Subject: Dresden Nuclear Power Station Units 2 and 3
Quad Cities Nuclear Power Station Units 1 and 2
Response to NRC Staff Request for Additional Information (RAI)
Regarding the Technical Specification Upgrade Program (TSUP)
Section 3/4.6, "Primary System Boundary"
NRC Docket Nos. 50-237/249 and 50-254/265

RESPONSE TO REQUEST FOR ADDITIONAL INFORMATION RE
TECHNICAL SPECIFICATION UPGRADE PROGRAM GENERIC
QUESTION NO. 1

ComEd Response to TSUP RAI Generic Question No. 1

ComEd Response to TSUP RAI Questions on TSUP 3/4.6

FIGURE 3.6.1.

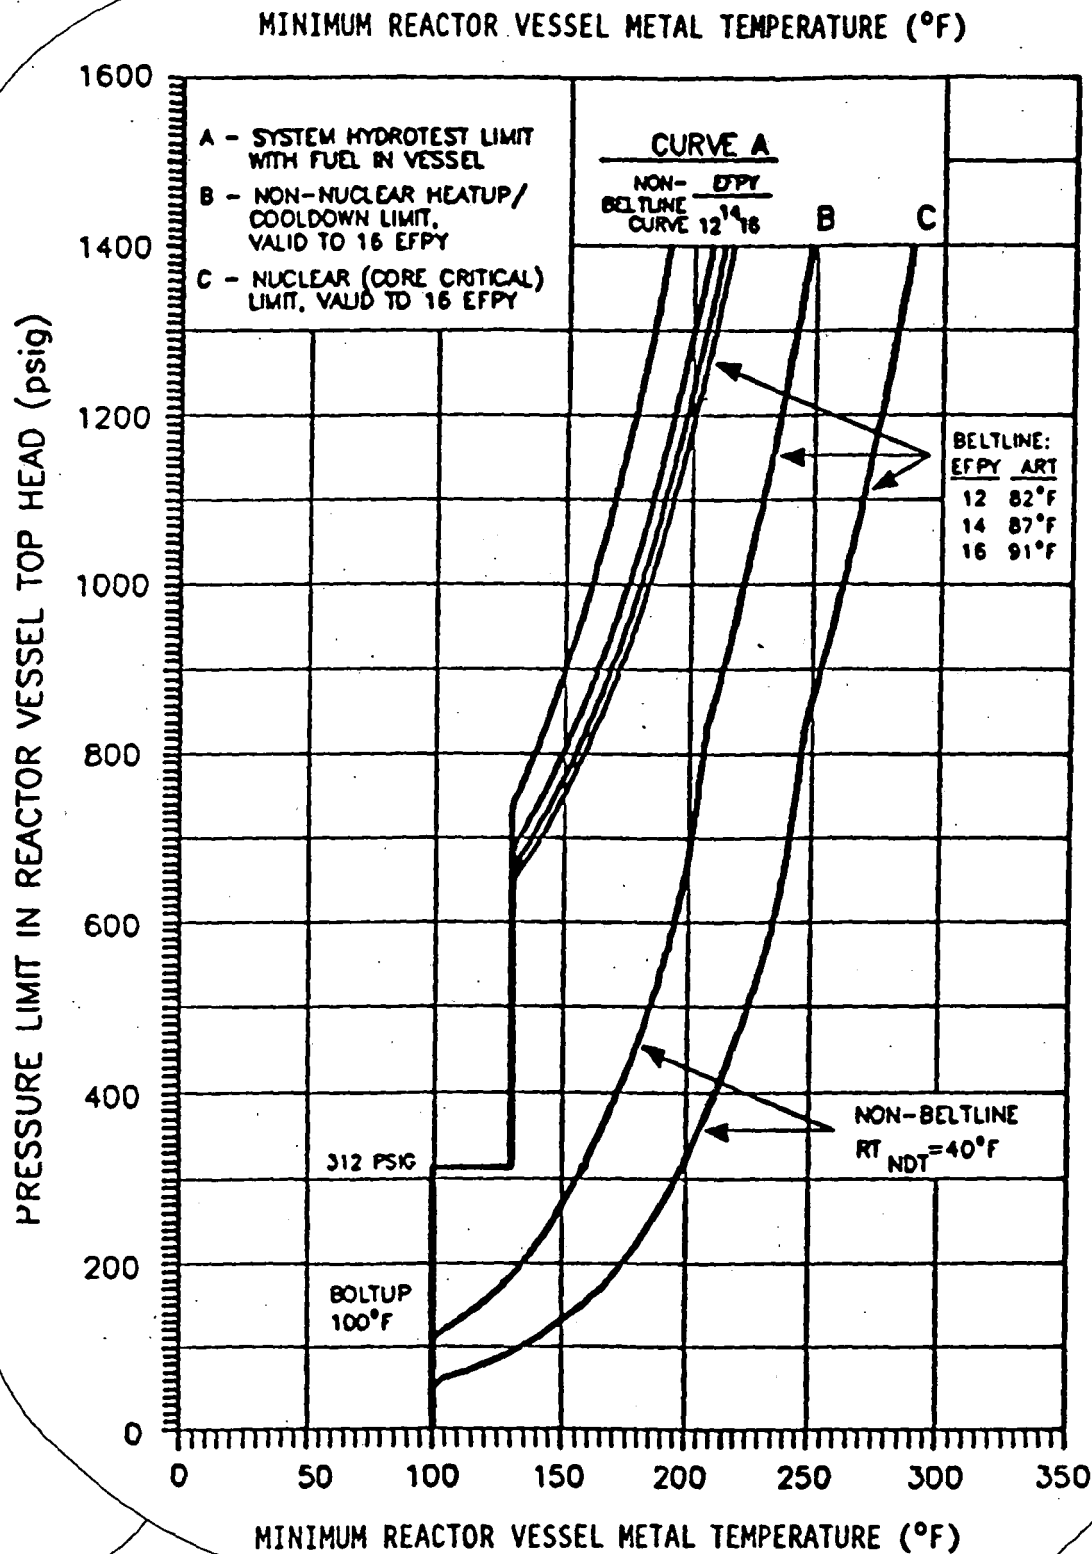
2. CTS 3.6.B.1 [regarding Figure 3.6-1 for Quad Cities and 3.6.1 for Dresden] is encompassed within TSUP 3.6.K, LCO and Figure 3.6.K-1 which is based on STS Figure 3.4.6.1-1. Proposed TSUP Figure 3.6.K-1 is identical to CTS Figure 3.6-1 for Quad Cities and CTS Figure 3.6.1 for Dresden.

5. CTS 3.6.B.2 for Dresden Unit 2 [regarding 80 °F] has been changed to be consistent with CTS Figure 3.6.1. CTS 3.6.B.2 for Dresden is consistent with CTS Figure 3.6.1. Proposed TSUP 3.6.K.4 corrects this discrepancy as the correct value is 100 °F. This is consistent to CTS Figure 3.6.1 and proposed Figure 3.6.K-1 for Dresden Station. The 80 °F minimum boltup temperature within the Unit 2 CTS 3.6.B.2 was consistent for an earlier version of CTS Figure 3.6.1 (DPR-19 Amendment 114). However, ComEd's review of GL 92-01 required an additional revision to CTS Figure 3.6.1 and the associated LCO 3.6.B.2. The revised curves reflecting the 100 °F were approved by the Staff for use with the receipt of DPR-19 Amendment 123; however, the corresponding revision to CTS 3.6.B.2 was inadvertently omitted. ComEd has identified this issue and controls this requirement under administrative measures.

FIGURE 3.6-1

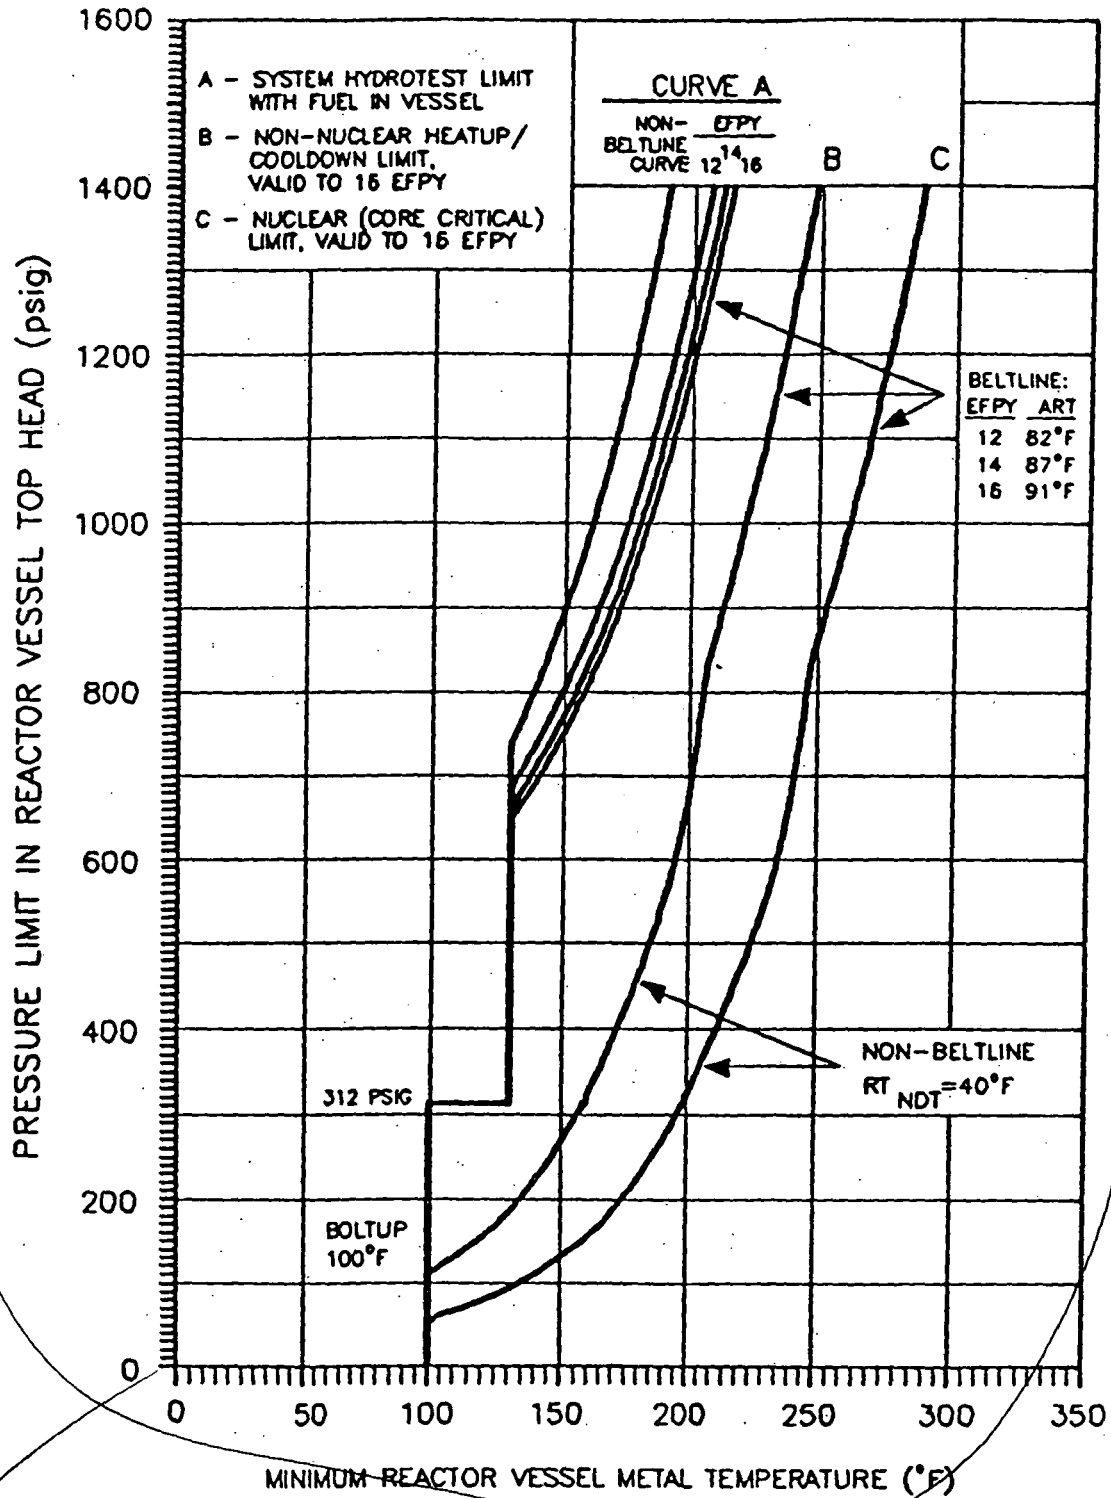
1. CTS 4.6.A.1 is encompassed within TSUP 4.6.K.1 which is based on STS 4.4.6.1. Proposed TSUP 4.6.K.1 deviates from STS Figure 3.4.6-1 as the CTS P/T Limits do not include reference to curves A', B' or C'. CTS Figure 3.6-1 for Quad Cities (CTS 3.6.1 for Dresden) has been retained in TSUP as Figure 4.6.K-1.
2. CTS 4.6.A.1 [regarding 15 minute intervals and permanent records] is encompassed within TSUP 4.6.K.1 which is based on STS 4.4.6.1.1. The surveillance frequency has been reduced from every 15 minutes to once per 30 minutes in proposed TSUP 4.6.K.1. The proposed reduction in the periodicity has a negligible impact on existing plant safety margins and provides an adequate frequency to monitor plant heatups and cooldowns. TSUP 4.6.K.1 has been shown based upon industry experience to provide an adequate level of safety regarding monitoring plant thermal transients.
